**PWROG-19047-NP-A**  
**Revision 0**

# **North Anna Units 1 and 2 Reactor Vessels Low Upper-Shelf Fracture Toughness Equivalent Margin Analysis**

FINAL SAFETY EVALUATION BY THE OFFICE OF NUCLEAR REACTOR REGULATION  
FOR THE PRESSURIZED WATER REACTOR OWNERS GROUP  
TOPICAL REPORT PWROG-19047-P/NP, REVISION 0,  
“NORTH ANNA UNITS 1 AND 2 REACTOR VESSELS LOW UPPER-SHELF FRACTURE  
TOUGHNESS EQUIVALENT MARGIN ANALYSIS”  
EPID: L-2020-TOP-0028

Figure 1: Charpy Model J-integral at Standard Conditions Vs. Normalized Watts Bar Unit 1 Data

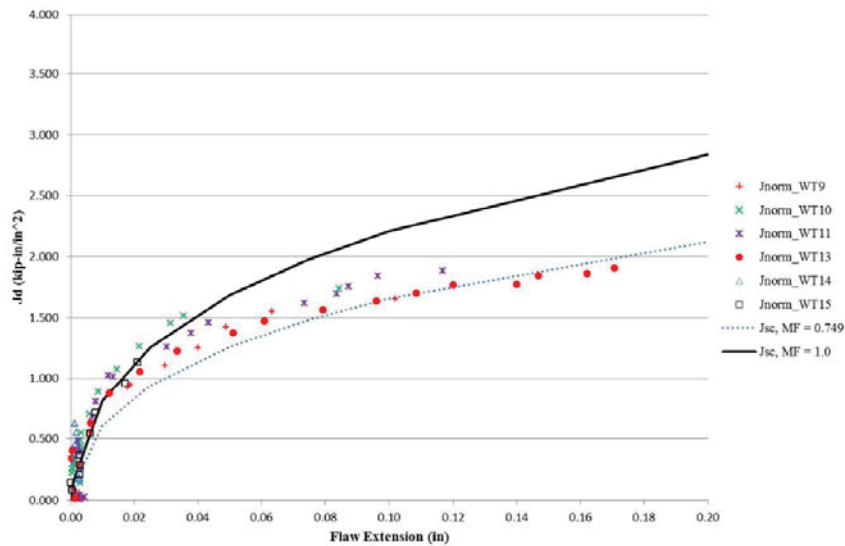
- a) Clarify the discrepancy in PWROG-19047 with regard to the explanatory variables (e.g., copper and fluence) of NUREG/CR-5729 model that are used in the EMAs for North Anna, Units 1 and 2.
- b) Provide the basis (with reference to the applicable current licensing basis documents) that the North Anna, Units 1 and 2, nozzle and shell forgings are **bounded** by the range of explanatory variables used to develop the J-R model (i.e., Table 11 of NUREG/CR-5729).

and X was J-R tested and reported in WCAP-16333-NP [15]; the normalized results are shown in Figure 1. The predicted USE values for Watts Bar Unit 1 Capsules W and X determined in accordance with Regulatory Guide 1.99 [6] are 45.9 ft-lbs and 44.0 ft-lbs respectively. The predicted NUREG/CR-5729, Table 11 Charpy model at standard conditions is also shown in Figure 1. The standard conditions and normalization procedure defined in NUREG/CR-5729 was used. An unirradiated nozzle dropout A508 Class 2 forging from a different Rotterdam fabricated RPV was also J-R tested by Westinghouse in 1992. This forging had a USE of 100 ft-lbs. The predicted NUREG/CR-5729, Table 11 Charpy model at standard conditions is shown in Figure 2 and Figure 3, which are compared to the normalized 300°F and 550°F test data respectively. Based on the comparison of measured data from Rotterdam forgings to the NUREG/CR-5729, Table 11 Charpy model used for estimating J-R curves in PWROG-19047, the model adequately represents the measured data, therefore, the model is deemed acceptable to be used in the analysis. The irradiated Rotterdam forging has a Cu value (0.155%) that is representative of the North Anna Units 1 and 2 forgings and has the highest fluence available for a J-R tested Rotterdam forging in the U.S. The USE values (44.0, 45.9 and 100 ft-lbs) used as inputs to check the Charpy model against measured J-R data bound those used in the EMA.

The statement in the RAI can be clarified as follows “The Charpy model is applicable to the North Anna Units 1 and 2 nozzle and shell forgings because the J-R model was validated against representative Rotterdam forgings with measured J-R data.” The Topical Report PWROG-19047-P (and -NP) will be revised as such.
